RE: JOHN & CHRISTINA CASEY – 3814 COUNTY ROAD 16
SITE PLAN REVIEW
TAX MAP NO. 112.00-1-19.111
CPN NO. 18-034
MRB PROJECT NO.: 0300.12001.000 PHASE 140

MRB has completed a review of the submitted Preliminary Site Plan regarding the above referenced project, dated May 17, 2018, prepared by Meagher Engineering. We offer the following comments for the Planning Board's consideration. A brief written response to each comment should be provided by the design engineer.

TYPICAL WATER SERVICE

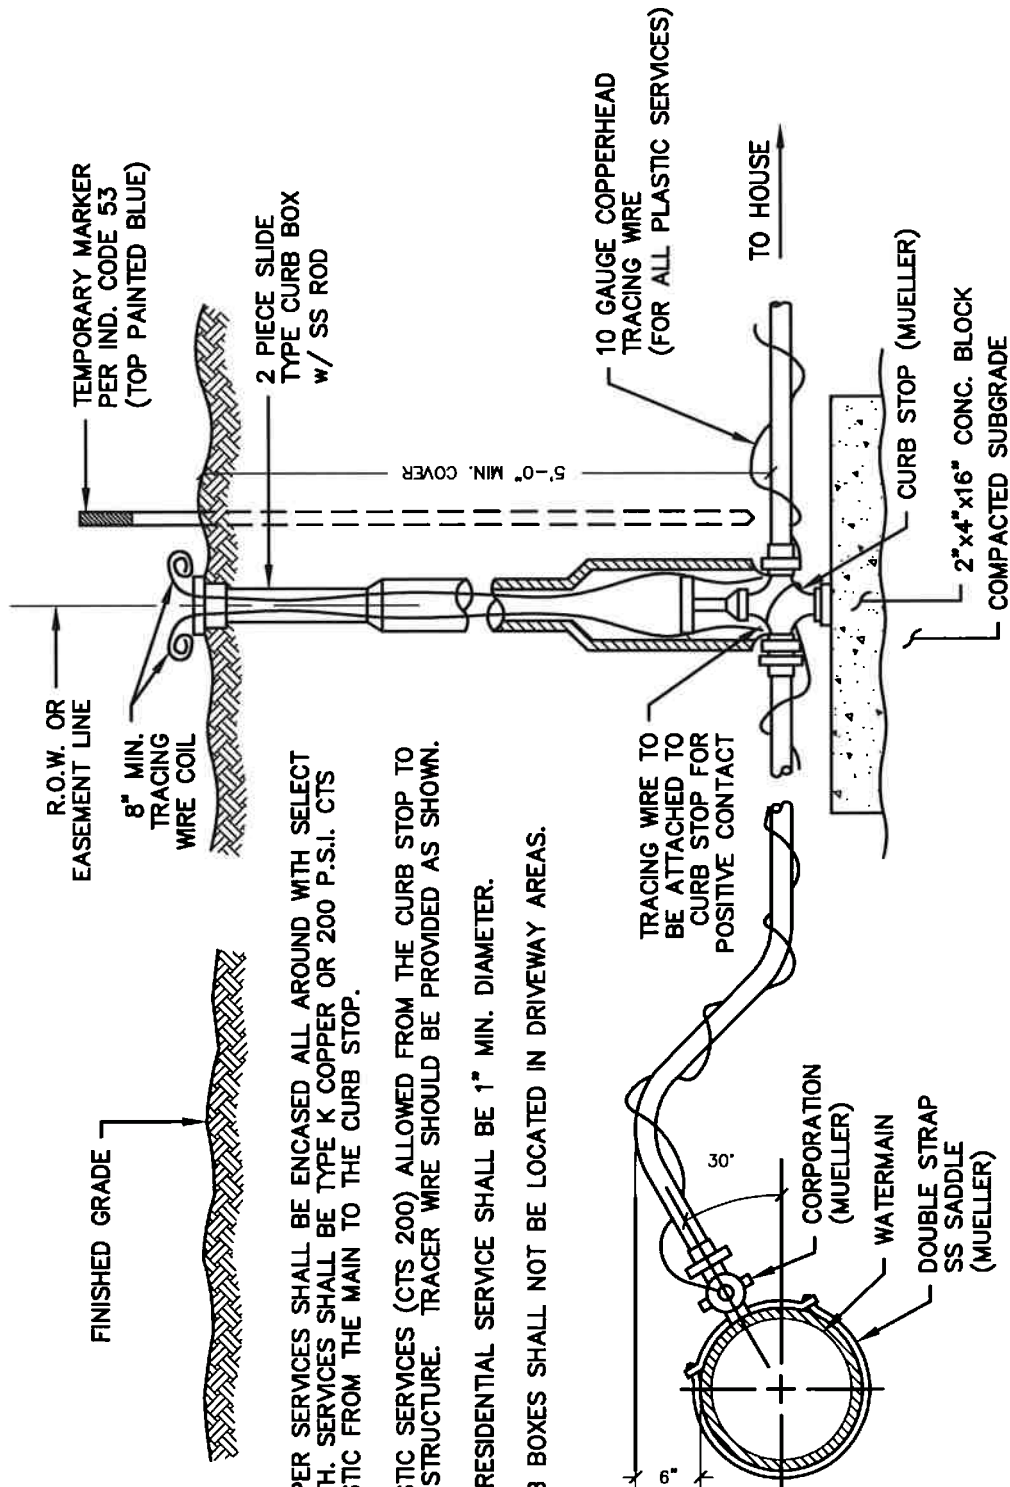
3. All existing utilities should be labeled with size, material, and inverts (if applicable). The plans should also be updated to indicate the location of the proposed service connections for Water and Sewer. A detail of the water service connection is to be added to the plans (attached).
